UNITED STATES PATENT AND TRADEMARK OFFICE

APPLICATION NO.	FILING DATE	FIRST NAMED INVENTOR	ATTORNEY DOCKET NO.	CONFIRMATION NO.
09/474,916	12/29/1999	YOSHIKI NANKO	SIC-99-036	2926

Office Action Summary

DETAILED ACTION

British
4599
3-2-99
Jones

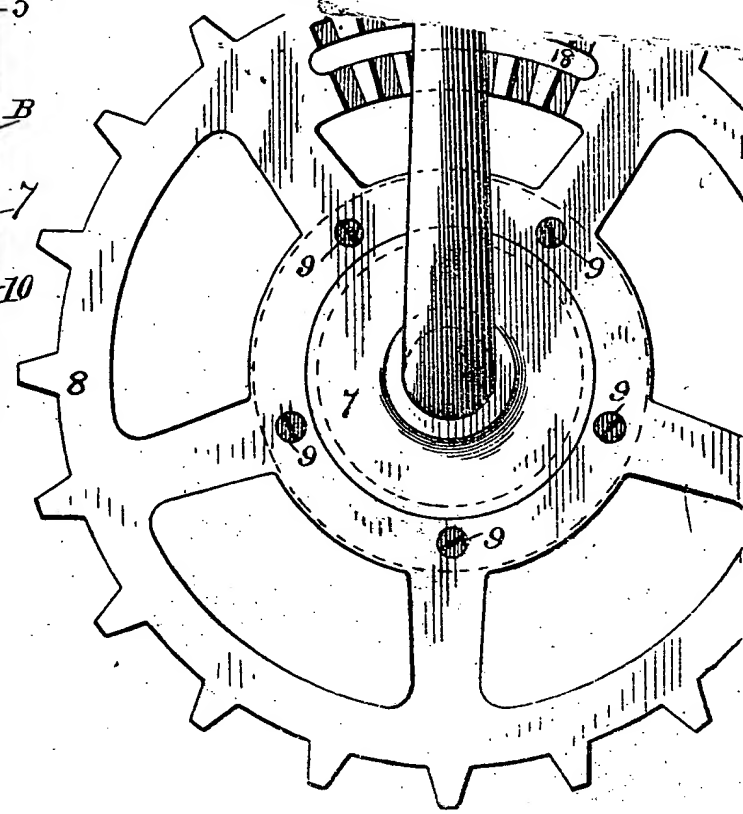
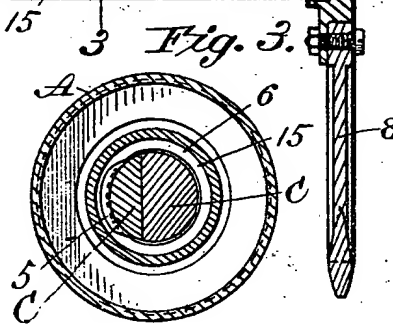
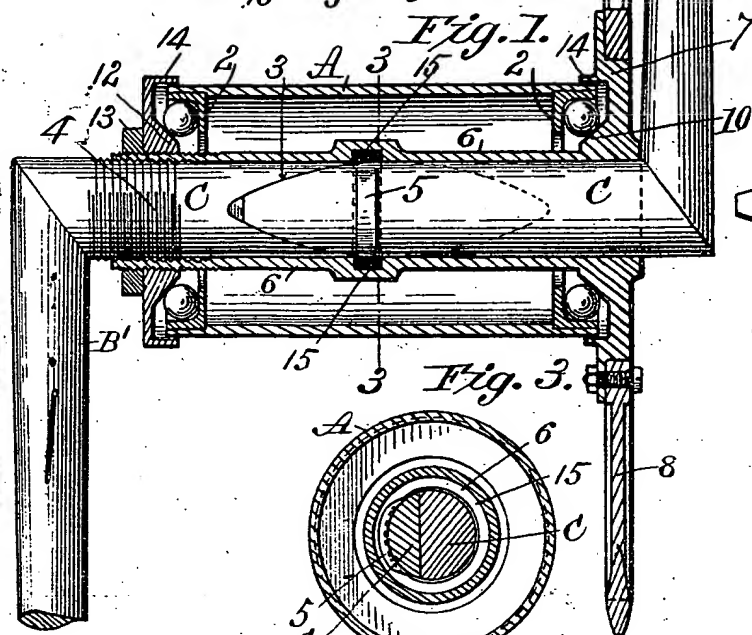
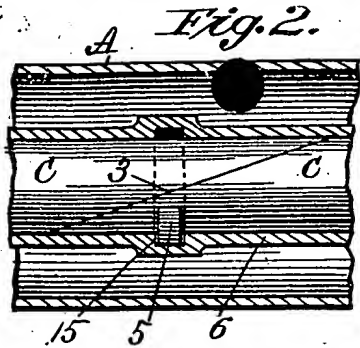
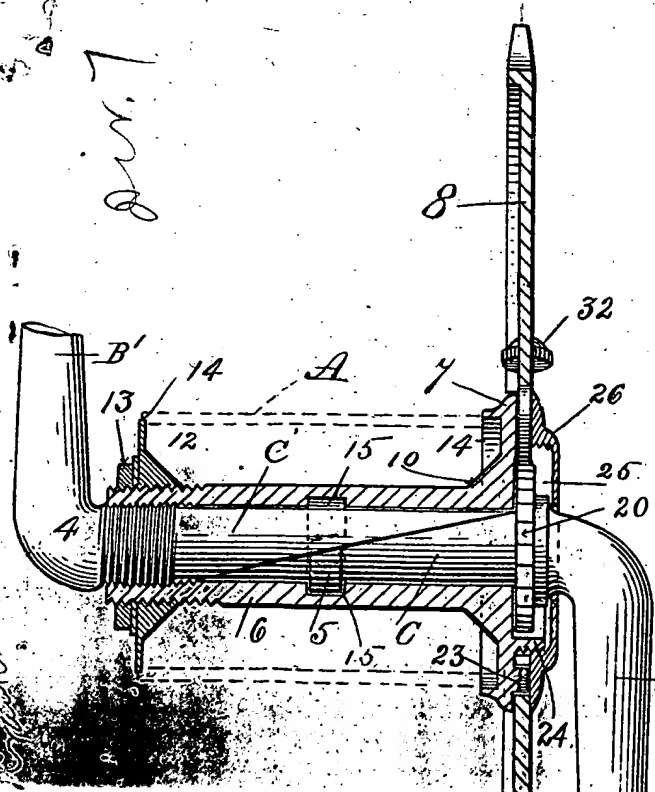
2. Claims 38 and 46 are rejected under 35 U.S.C. 102(b) as being anticipated by UK(4599). UK(4599) discloses a drive mechanism comprising a crank arm (fig. 1) having a crank axle hole (B) around a rotational axis, a drive member (20) non-rotatably fixed to the crank arm, and including an abutment facing a forward rotational direction and a slop extending from the radially outer surface of the abutment and facing a rearward rotational direction and the drive member is not used to couple sprockets to the crank arm. It is apparent that the abutment rotates around the rotational axis at a substantially constant radius.

4. Claims 1-2, 4, 8-12, 14-15, 19-20, 31, 39 and 47 are rejected under 35 U.S.C. 103(a) as being unpatentable over UK(4599) in view of FR(1,028,488). In claims 1, 31 and 47, UK(4599) discloses a drive mechanism comprising a crank arm (fig. 1) having a crank axle hole (B) around a rotational axis, a drive member (20) supported coaxially with the rotational axis, and including an abutment facing a forward rotational direction and a first slop extending from the radially outer surface of the abutment and facing a rearward rotational direction and the drive member is not used to couple sprockets to the crank arm. UK94599) does not disclose that the crank arm has an axle mounting hole and a plurality of splines in the crank axle mounting holes. It is well known in the art to provide a crank arm with an axle-mounting hole having splines so as to facilitate easy removal and assembling of the drive system. FR(1,028,488) discloses a crank arm that includes crank axle mounting hole with splines in order to facilitate quick and easy dismantling and assembling of the drive system. Therefore, it would have been obvious to one of ordinary skill in the art at the time of the invention to modify the crank arm of UK(4599) so as to include an axle mounting hole having splines in view of FR(1,028,488) in order to facilitate quick and easy dismantling and assembling of the drive system.

In claim 9, note the first abutment surface is 180 degrees from the second abutment (see drawing illustration attached).
